Acoustic Review Report

Byron Bay Bypass

Butler Street Upgrade

Report No 3599R2 7th June 2016

Plate A1: Potential acoustic barrier location, Northern Section

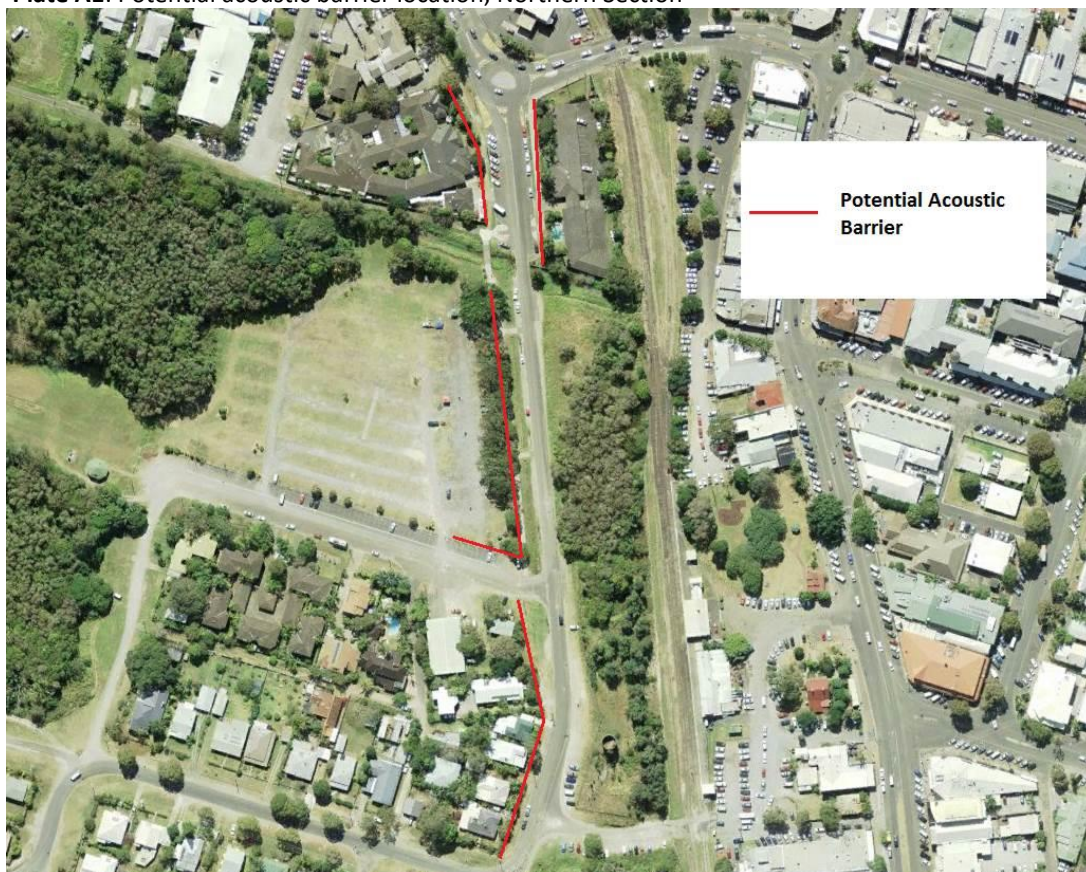
The intent of the ONMP is to maximize screening from acoustic barriers where reasonable and feasible. Indicative barrier locations are presented in **Plate A1** and **Plate A2** below. Barrier locations will be removed from consideration where determined to be unreasonable or unfeasible on a site specific basis. Maximum reasonable barrier heights will be determined by Council in liaison with community stakeholders.
